SUBJECT: Additional Hydrogeologic Work at
William Dick Lagoons

DATE: 5-9-91

FROM: ^{KB}
Kathy Davies, Hydro

I have reviewed the proposed work presented by Geraghty and Miller per letter to you of December 12, 1990 and have the following comments:

William Dick Lagoons Site Surrounding Water Supplies Sampled to Date

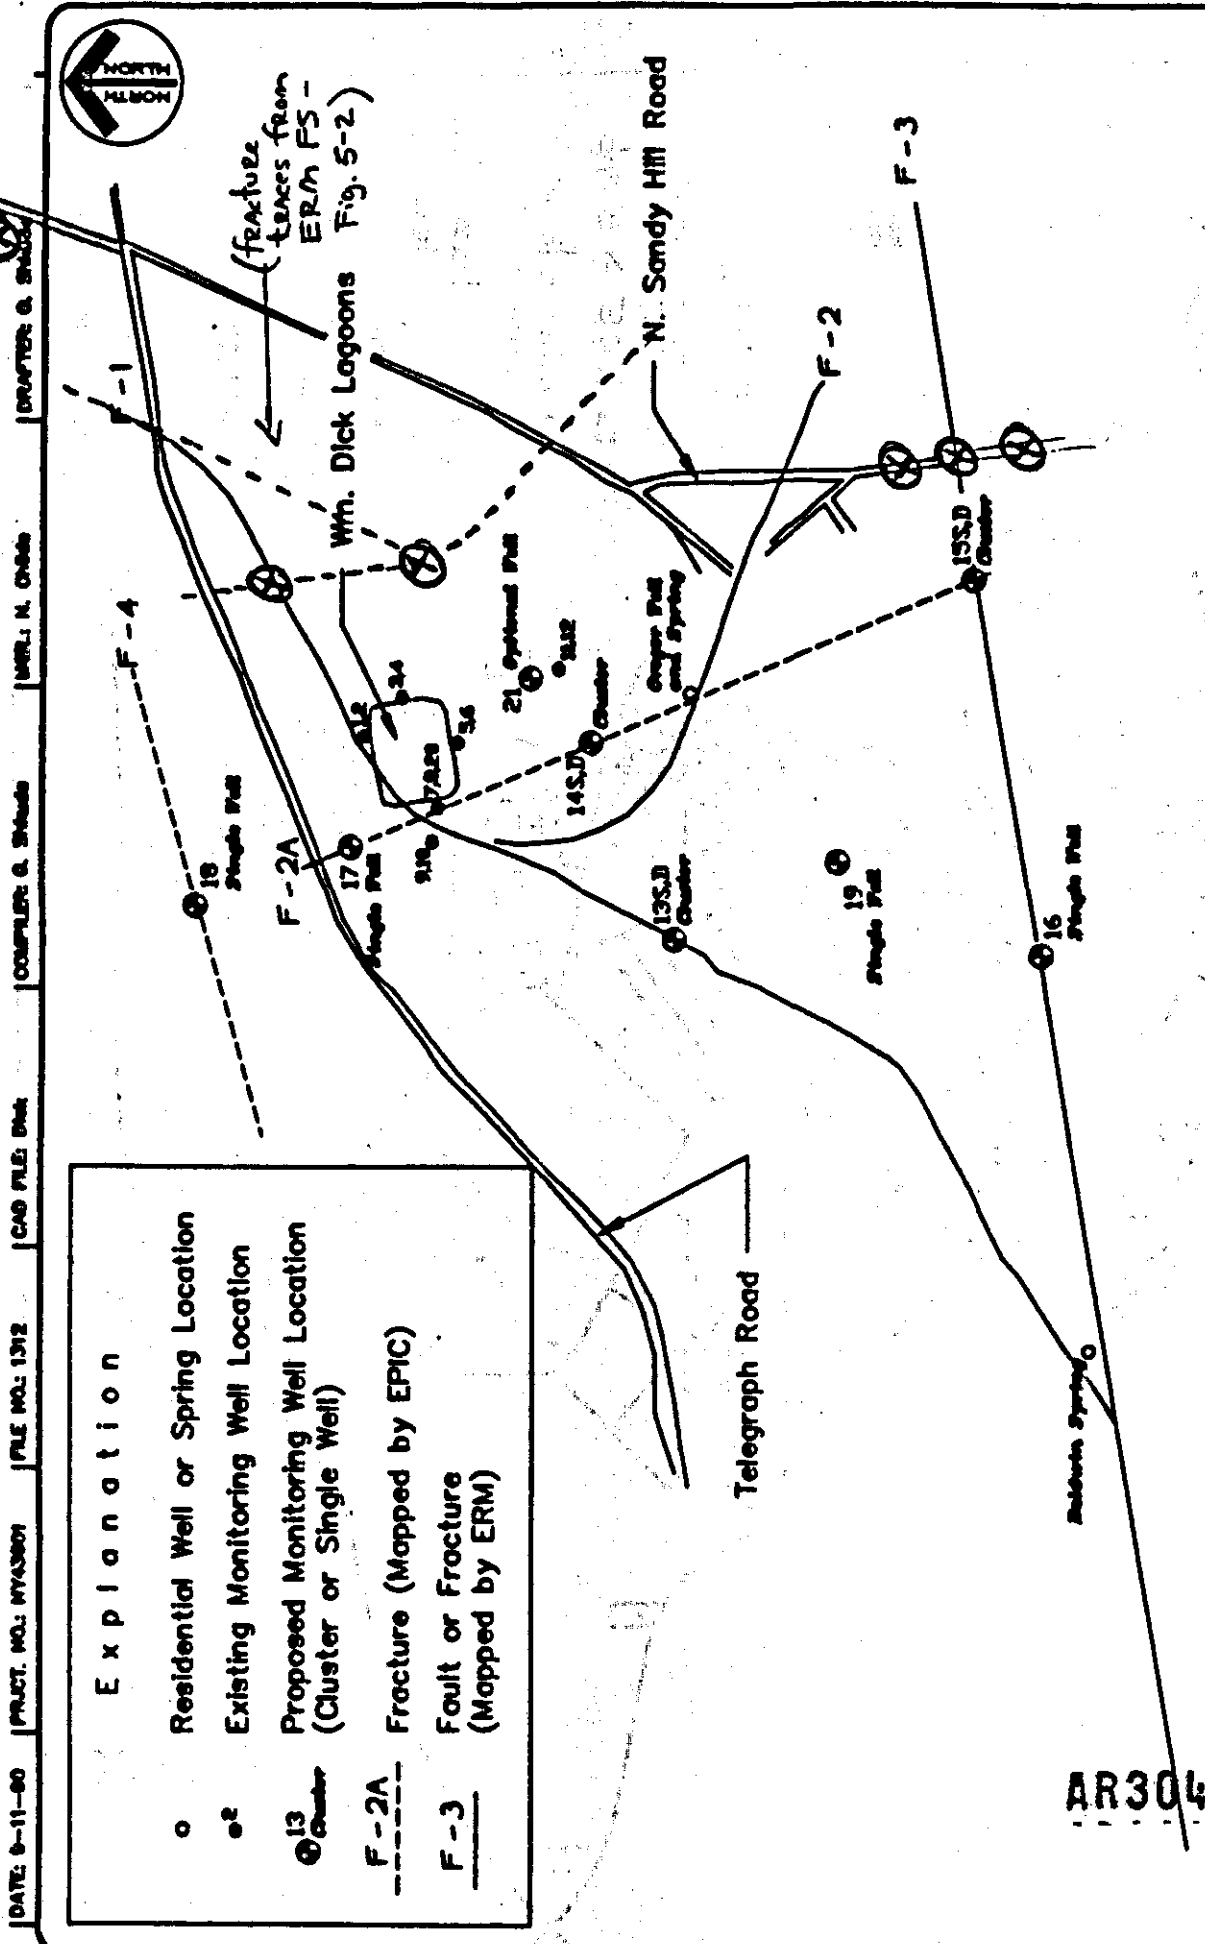
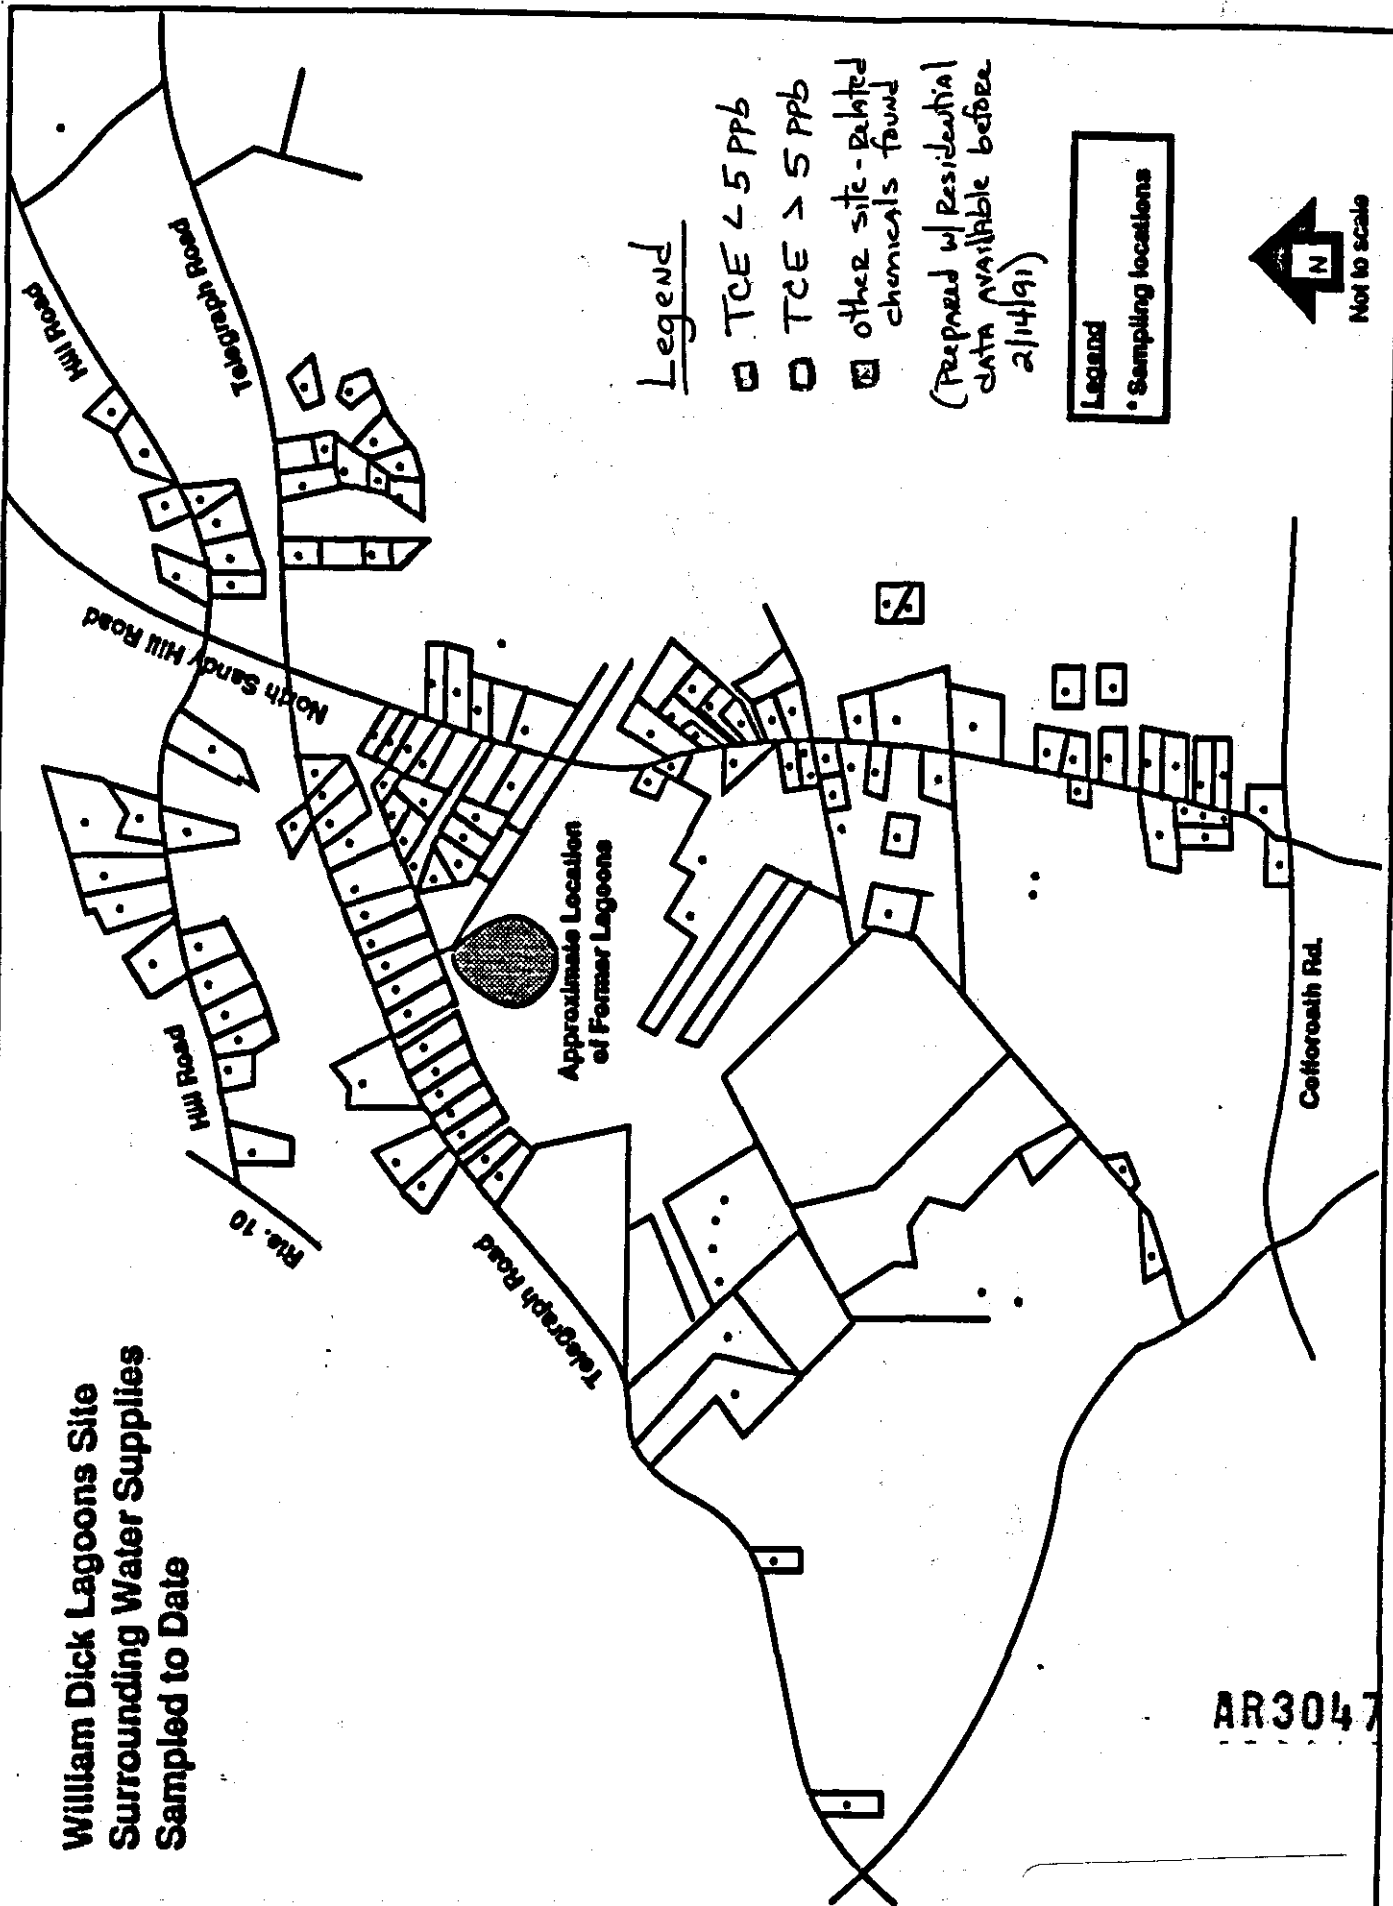
The approximate well locations proposed by G&M seem to be appropriate as an initial step in further characterizing the site. If you are interested in gaining more insight to the interconnectivity of the site and contaminated residential wells, then I think we need to look at available well construction information for the residential wells and add a few additional monitoring wells between the lagoons and the home wells. I have sketched pertinent geologic features, such as the fault and fracture traces, as well as a few possible new well locations on the attached map.

Added wells per K. Davics 5/9/91
